Middleton City Council

Findings of Facts, Conclusions of Law & Order

In the Matter of the applications of M3 and JUB Engineers for annexation/rezone, preliminary plat, development agreement, and comprehensive plan map amendment with respect to the Quarry East Subdivision located at 21500 Middleton Road and 11436 Lincoln Road:

STAFF REVIEW AND REPORT

Existing Conditions*

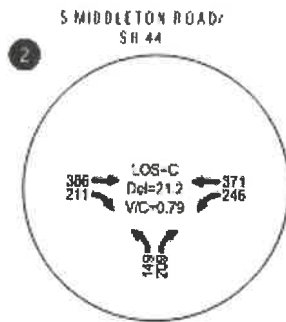
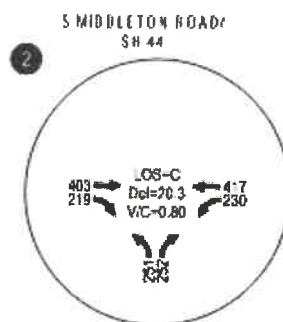
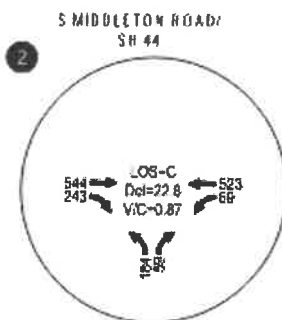
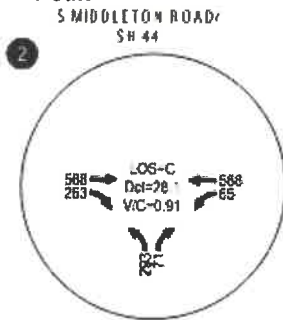
* The metrics shown in these figures are inaccurate because they incorrectly include a combined thru/right lane for eastbound traffic. An existing conditions analysis was not performed with the actual existing lane configuration, but since the actual existing conditions would improve performance and the TIS analysis meets ITD performance criteria, it is clear that the intersection would meet performance criteria with the correct lane configuration.

* The metrics shown in these figures are inaccurate because they incorrectly include a combined thru/right lane for eastbound traffic. The "mitigated" analyses are the actual existing lane configuration which includes separate thru and right lanes for eastbound traffic. The analysis results are:
